Ref. No.2014106109
Petition No. ~~224~~ 316

- () Involved; the nature of our services, and the estimated costs of removing and/or rerouting such services are:
- (x) Involved; The request for berm parking into Chalmers Ave. at 11306 Chalmers Avenue (with Parking) as outlined in petition # 316 is approved provided that the following conditions are met with:

NOTICE OF PROPOSED CHANGE IN PROPERTY Second Notice 12/5/14

**REQUEST BERM USE
 INTO CHALMERS AVE.
 AT 11306 CHALMERS AVE.
 (With Parking)**

SKETCH #1

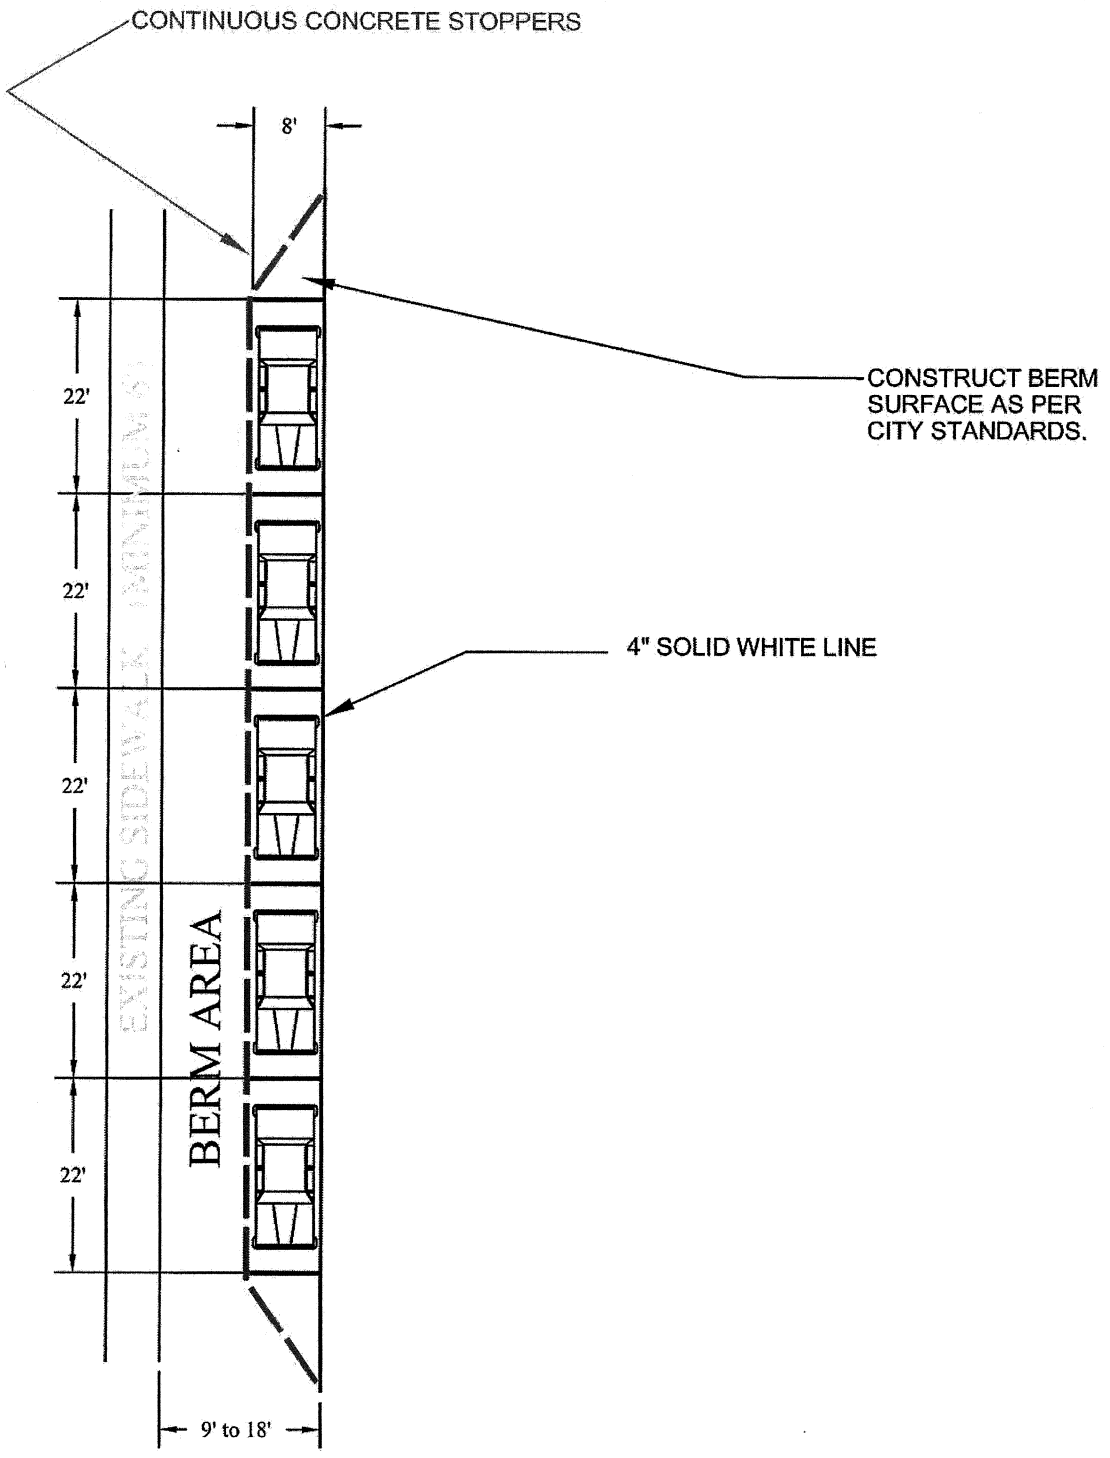
1. Requestor shall be responsible, at his/her expense, to install/ maintain continuous concrete stoppers for separation of vehicular and pedestrian usage as shown on the attached typical drawing by Traffic Engineering Division dated 05/13/2009 showing the layout of the berm parking.

6. This request is approved only for parallel parking. On street parking along the stretch adjacent to the berm parking will not be permitted

NOTE: ON STREET PARKING
WILL NOT BE PERMITTED.

CITY OF DETROIT CITY ENGINEERING DEPARTMENT SURVEY BUREAU	
JOB NO.	01-01
DRWG. NO.	X 316

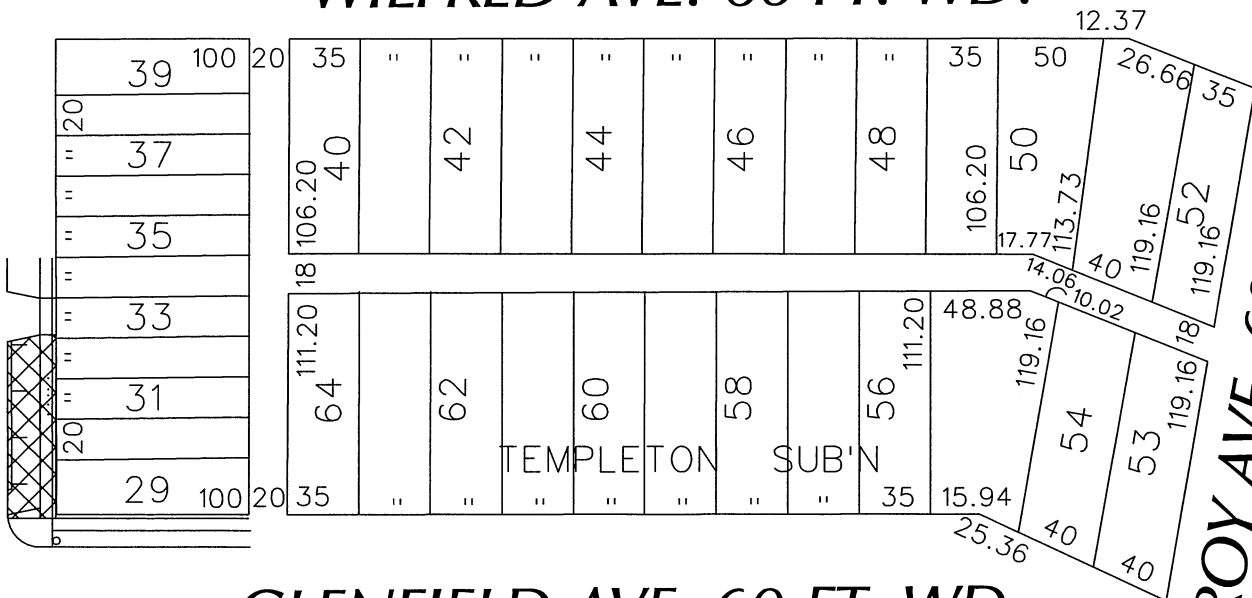
2. Requestor shall be responsible, at his/her expense, to construct/modify the berm surface as per City standards. Requestor shall be responsible to remove curb along the edge of the berm parking to allow for entry/exit. Requestor shall be responsible for maintaining the berm surface and removal of snow from the berm area, at his/her expense.

3. The requestor shall be responsible, at his/her expense, to install/maintain parking control signs and pavement markings associated with the berm parking as per City standards.
